SNPP MEMO

Panel Reference	PPSSNH-43
DA Number	DA347/19
LGA	North Sydney
Proposed Development	Alterations and additions to North Sydney Pool including new 50m pool, upgrade to 25m pool, new water play area, sundeck, grandstand, upgrade of facilities. Hours of operation 5am to 12 midnight seven days.
Street Address	4 Alfred Street South, Milsons Point
Applicant/Owner	North Sydney Council c/o Brewster Hjorth Architects Pty Ltd
Owner	North Sydney Council
Date of DA lodgement	30 October 2019
Regional Development Criteria (Schedule 7 of the SEPP (State and Regional Development) 2011	Council related development over \$5 million

Referral response – Sydney Trains

Figure 3b Proposed modifications to access ramp to allow the “wheel envelope” of a 19m semi-trailer - access to Luna Park – over Council land. Source – taken from Luna Park Sydney | JMT Consulting Traffic Review – prepared for Luna Park 15 May 2020.

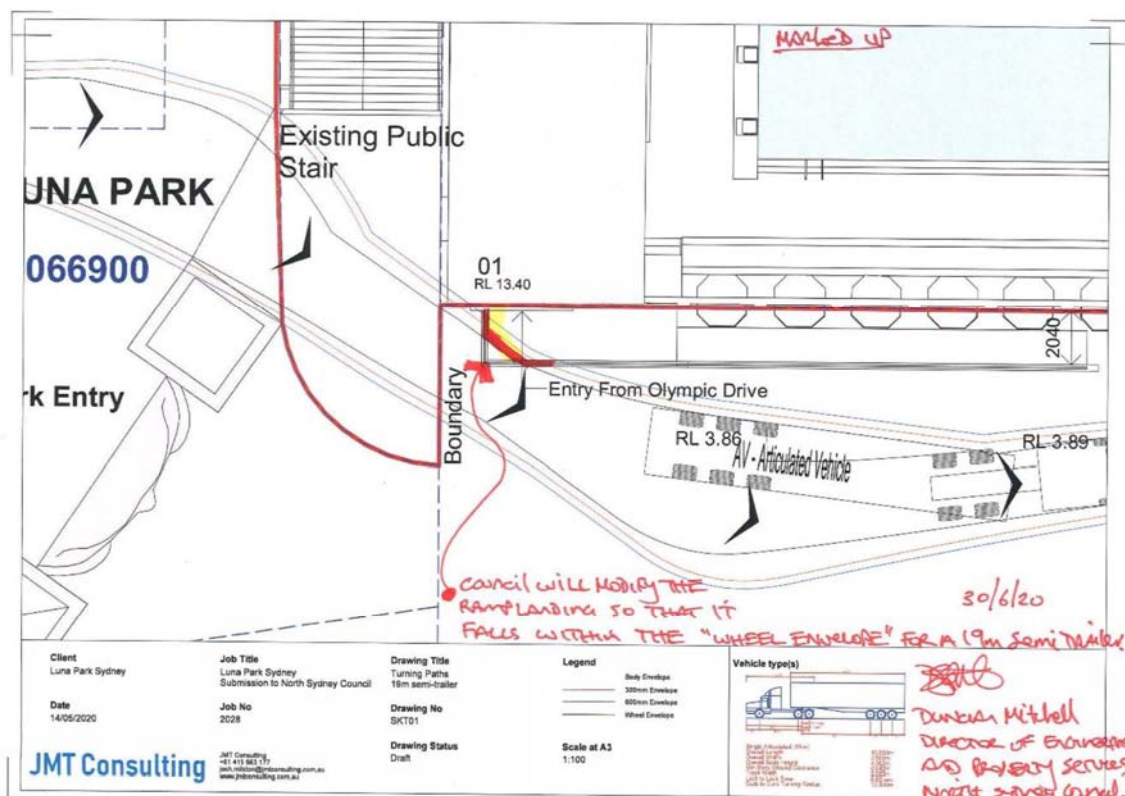
A further submission has been received from Luna Park Pty Ltd, dated 15 May 2020 but provided to me on 30 June 2020. It includes swept path diagrams for a 19m semi-trailer that identifies the obstruction created by the proposed pedestrian ramp in Olympic Drive. The following diagram has been taken from that submission and marked up by the applicant to identify the area of conflict:

It is considered that a resolution to the conflict lies in amending the design of the ramp so that it does not restrict vehicular access to Luna Park in a way shown in the diagram above. Consequently, it is recommended that condition A5 be reworded to read:

The proposed pedestrian access ramp on Olympic Drive is to be amended so that the profile at the end of the ramp is angled (Chamfered) at 45 degrees so that it falls outside of the wheel envelope of a 19m semi-trailer and does not impede access into and out of the gates to Luna Park adjacent to the western end of the pool concourse.

Amended plans are to be provided to Council’s Manager Development Services for approval prior to the release of the Construction Certificate.

3	Pedestrian Ramp at South Western Corner

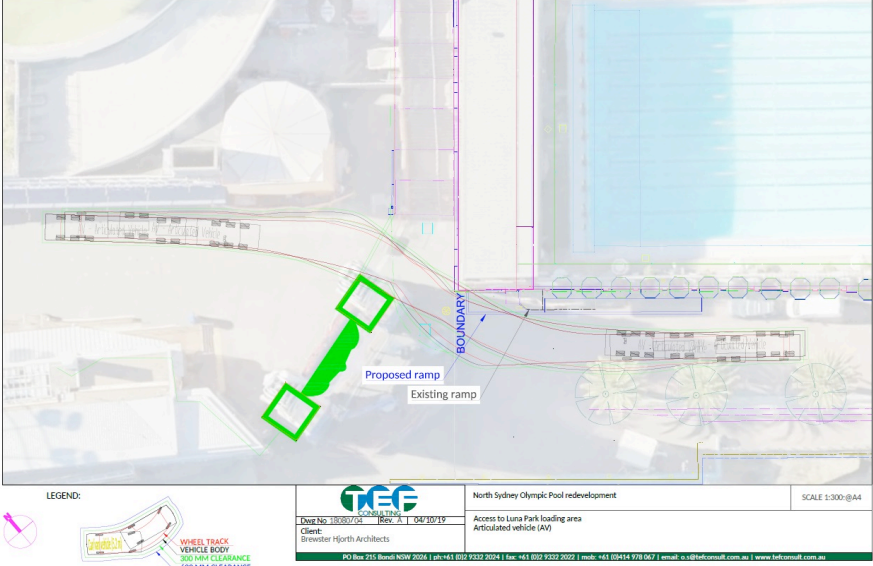
No	Item	Advised Impact/ Requested Action	Response	Design Change
3.1	Luna Park Sydney Pty Ltd has made submissions which state:	Luna Park has confirmed that vehicles requiring access to the site exceed the standard heavy rigid vehicle that has been modelled in this swept-path-analysis and include:	<p>In response to the submission from Luna Park on the amended Development Application Plans and the independent planners request that the plans for the redevelopment of the pool (Item 3 - Pedestrian Ramp in the South West Corner) <i>“must be amended to accommodate these larger vehicles”</i> (Semi Trailers, Large Fire Brigade Aerial Equipment, 300 tonne – mobile cranes and vehicles larger than HRV and MRV”), the applicant would like to advise that the ramp is important to the success of the redeveloped North Sydney Olympic Pool in meeting its Disability Discrimination Act (DDA) obligations and is also required for the new facility to meet egress requirements as per the current Building Code of Australia (BCA) standards.</p> <p>A review of the design was undertaken by Councils Access & Inclusion Coordinator before the Development Application was lodged in October 2019 and it was recommended that ramp access be provided for in this location. The ramp has been designed in this location to specifically cater for the needs of people in wheelchairs and or who have mobility issues and are arriving to the pool by ferry (Milsons Point Ferry Wharf). The ramp provides access to the new Gym / Program room located on Level 1. (Refer to figure 1 - Architectural Plans Ao12 – Rev U – Level 1).</p>

No	Item	Advised Impact/ Requested Action	Response	Design Change
			<p>If the ramp is removed or modified so that it no longer meets DDA or BCA standards, these facility users would have to make their way up to another on grade entry located adjacent to the level 1 café and then back to the gym and program room on level 1 which is a round trip of over 150m. Alternatively these users would have to make their way to the main entrance to the pool on Alfred Street which is 200 meters away and up a steep incline (the gradient to get up to the main entrance on Alfred Street is greater than 1:8). These users would then have to catch a lift down to level 1 and make their way through the level 1 corridor or pool concourse to the Gym / Program room on level 1. A round trip of over 350m.</p> <p>Removing the ramp from this location would significantly disadvantage people in wheelchairs or with mobility issues as it would introduce unnecessarily long travel distances to get to parts of the new pool facility that these users desire to use.</p> <p>The ramp in this location is also required for egress of the south western side of the facility (Level 1) to satisfy the requirements of the BCA.</p>  <p>Figure 1. Architectural Plans Ao12 – Rev U – Level 1 Plan showing location of access ramp.</p>
